# Cheminert UHPLC Valves and Selectors

## Notice of Design Change

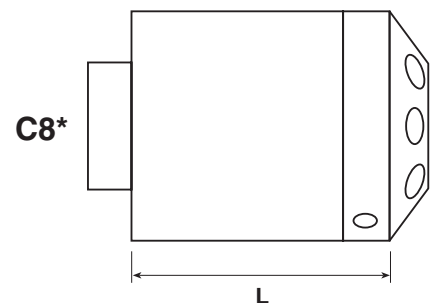
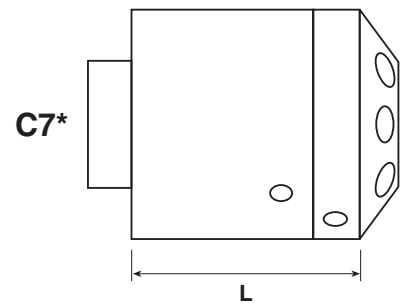
As of early 2015, C7\* UHPLC injectors, switching valves, and selectors with 1/32" and 1/16" fittings have been upgraded to the C8\* design. The only modification is a longer body to accommodate a slightly different spring arrangement. The new arrangement provides more consistent spring force, resulting in better performance and lifetime.

The temperature and pressure specifications, port sizes, rotors, and stators remain identical.

Valves with 360 micron fittings remain unchanged, and retain the C7\* part number designation.

Number of ports or positions	C7* (older)		C8* (current)	
	mm	in	mm	in
4	38.15 mm	1.5"	44.45 mm	1.75"
6	38.15 mm	1.5"	44.45 mm	1.75"
8	40.15 mm	1.58"	44.45 mm	1.75"
10	40.15 mm	1.58"	44.45 mm	1.75"
